MEMORANDUM FOR: J. C. Stepp, Chief, Geosciences Branch, DSE

SUBJECT: EXAMINATION OF NEW TRENCHES EXPOSING THE FAULT AT NINE
MILE POINT AND RECENTLY DISCOVERED FAULTS IN THE INTAKE
TUNNEL SHAFT

A meeting was held on 14 April, 1977 at the Nine Mile Point Unit 2 site among representatives of Niagara Mohawk Power Company, its geotechnical consultant Dames and Moore, the New York Geological Survey and the Nuclear Regulatory Commission. A list of attendees is enclosed. The purpose of the meeting was to examine new trenches, review the results so far of the investigation program and to examine several recently discovered minor, low angle thrust faults in the shaft to the cooling water intake tunnel.

Fig. 1 Location of faults, trenches, test borings, and site of overcore stress measurements

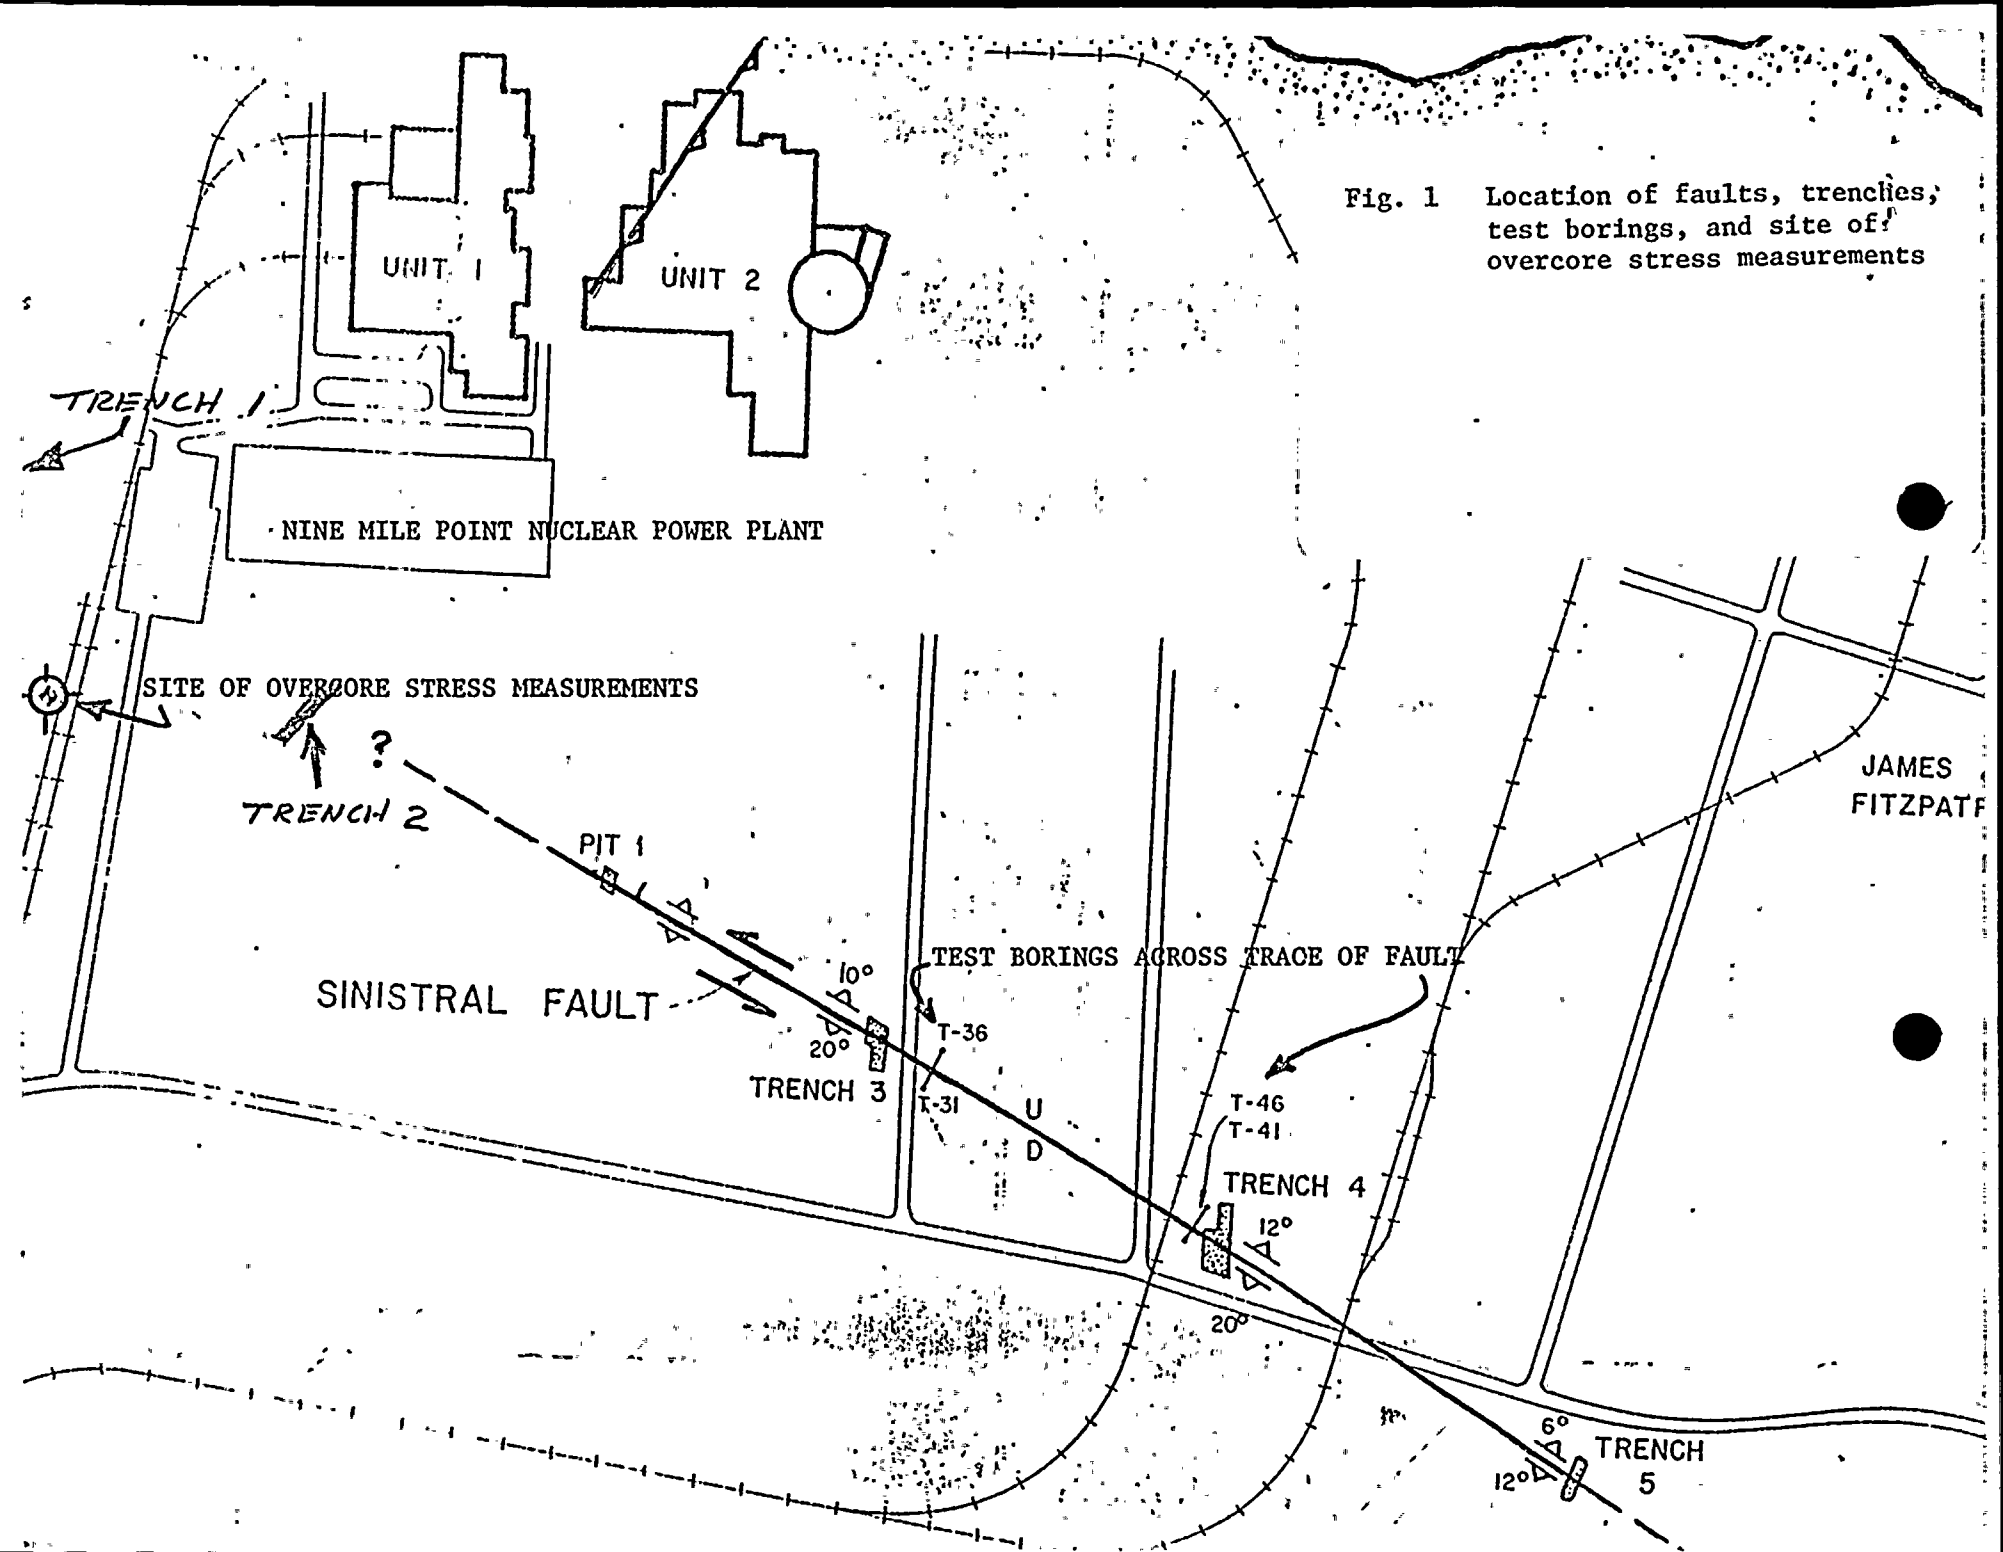
The Applicant had completed one new trench (trench 5) since our last visit in December, 1976 (see fig. 1 for locations of features mentioned). Also completed were geomorphic studies, initial borings along two north-south lines across the fault and a series of in situ stress measurements in one borehole.

We examined 3 low angle thrust faults near the bottom of the entrance shaft to the cooling water intake tunnel. The faults strike northeast and dip toward the southeast. By noting similarities to other similar structures in the site region, the Applicant attributes their origin to Paleozoic deformation.
